ORDER UNDER SECTION 96 (2) OF ACT, III OF 1901.

With reference to his application, dated 15th April 1918
 Mr *Bhaji D. Newandram* is informed
 that the plan submitted by him for building a *lungalow*
 on plot No 19^a, Survey Sheet 711
 situate in *Sea Field Road Civil Line*
 Quarter, is approved, and permission to build in accordance therewith is
 granted. The building to be erected subject to the By-laws and Rules of the
 Municipality.

SHOWING PROPOSED BUNGLOW
ON PLOT NO 192 SHEET FII
CIVIL LINE QUARTERS
SCALE 1/4" = 1' INCH

PLAN
SHOWING PROPOSED BUNGLOW
ON PLOT NO. 19A SHEET FII
CIVIL LINE QUARTER
SCALE 8 FT = 1 INCH

Architect & Surveyor
H. H. H. H.

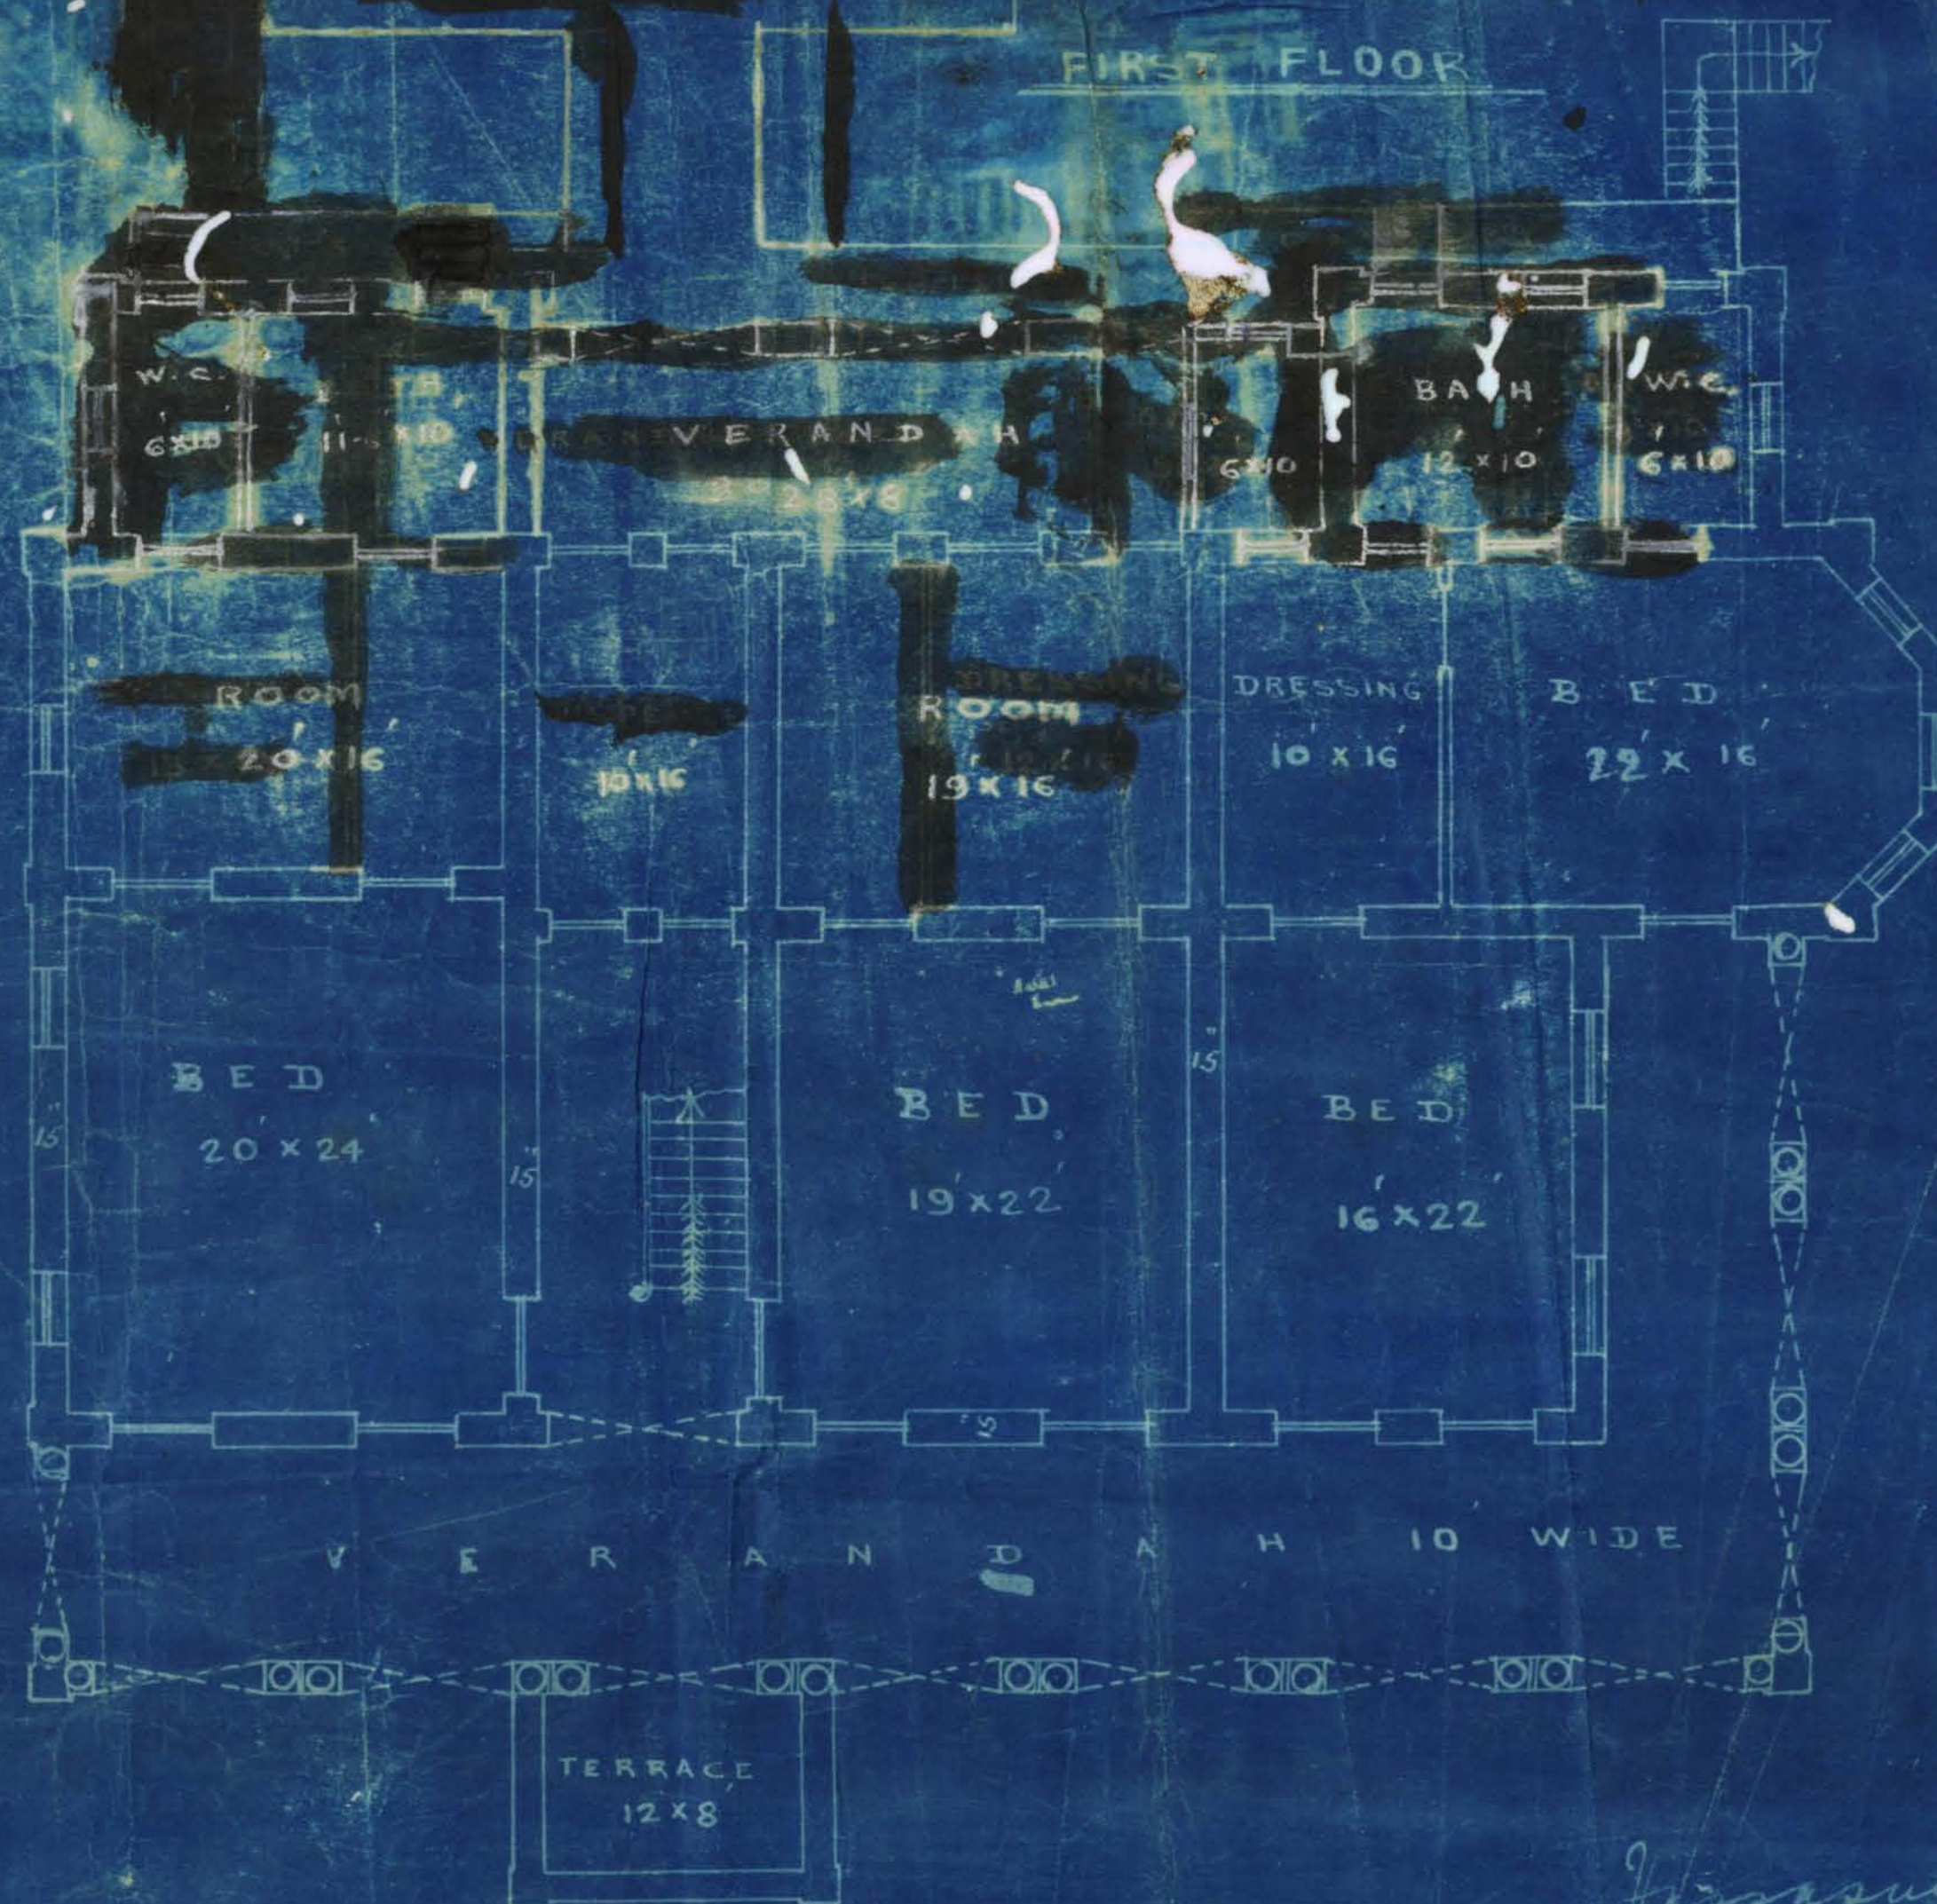
Remarks See. With reference to this I have to report
that the applicant wants to build a
bungalow with outhouse - This is a large
area to be covered with bungalow & outhouse.
Yours obediently

Given the area of the plot, the area covered with buildings
shows up on the ground. 1/27/18

With reference to
 your endorsement I beg
 to report that area of the
 plot is 420 square yds
 and the proposed
 building is 1024.
 square yds.
